CITY OF VANCOUVER  
COMMUNITY SERVICES GROUP

DEVELOPMENT PERMIT STAFF COMMITTEE REPORT  
JUNE 21, 2006

1068 WEST BROADWAY (COMPLETE  
APPLICATION)  
DE410287 - ZONE C-3A

Figure 2

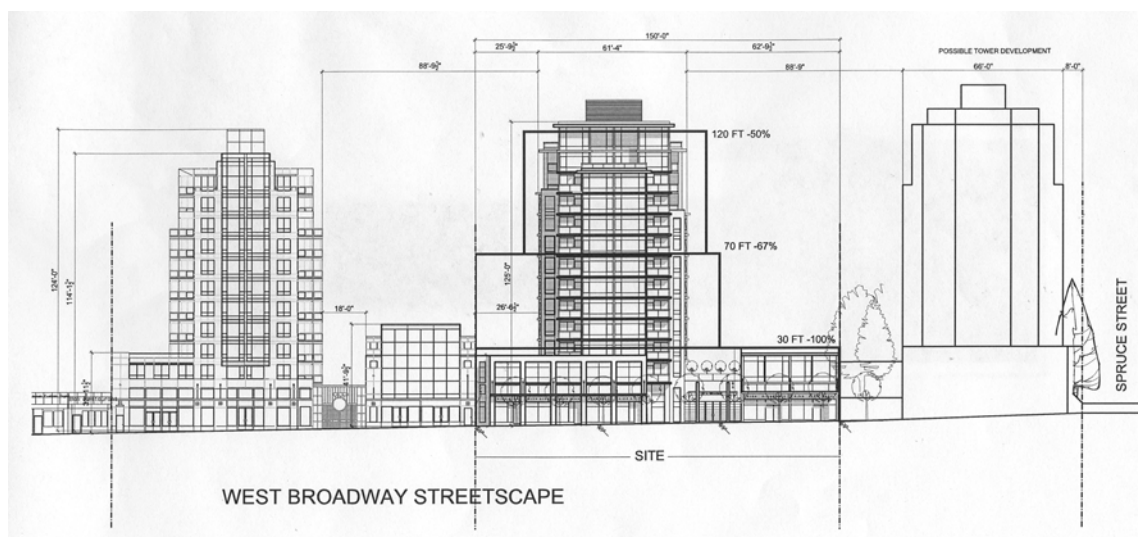
Figure 2, below, shows a comparison between the proposed building and a Guideline massing. This illustrates that the proposed building is significantly slimmer in both the mid-rise and high-rise portions of the building, than the Guideline form. This has the positive effect of both reducing shadows on the street and improving sun access and views through the site. See Figure 3.
